## CERTIFICATE OF APPROPRIATENESS

**Applicant:** Sam Gianukos, Creole Design, for Heloise Ellzey, owner

**Property:** 430 Omar Street, Lot 8, Block 16, Woodland Heights Subdivision. The property includes a historic 1,680 square foot, two-story wood frame single-family residence situated on a 5,000 square foot (50' x 100') corner lot.

**Proposal:** Alteration – Raise the existing foundation and replace several non-original windows.

## FIRST FLOOR

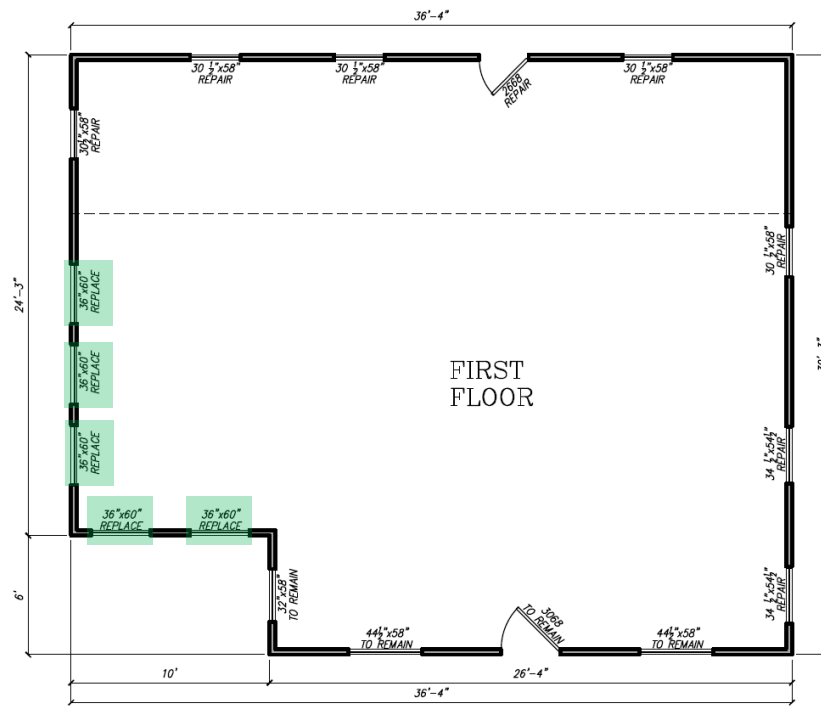
Not Original  
(To Be Replaced)

The five non-aluminum replacement windows will be replaced with new double-hung wood windows with a 6-over-6 lite pattern (with exterior muntins). No evidence of damage was submitted with the application for the three windows on the second-story, and therefore staff cannot make an assessment of their condition. These windows are to remain. See drawings, photos, and window details for more information.

## SECOND FLOOR

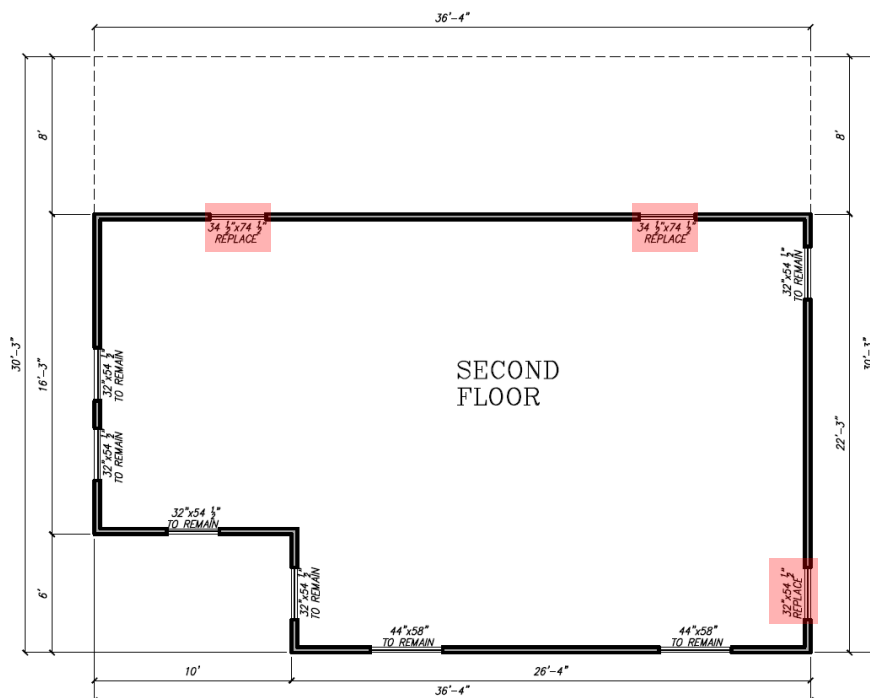
To Be Replaced  
(No Submitted  
Evidence of Damage;  
Not Considered)
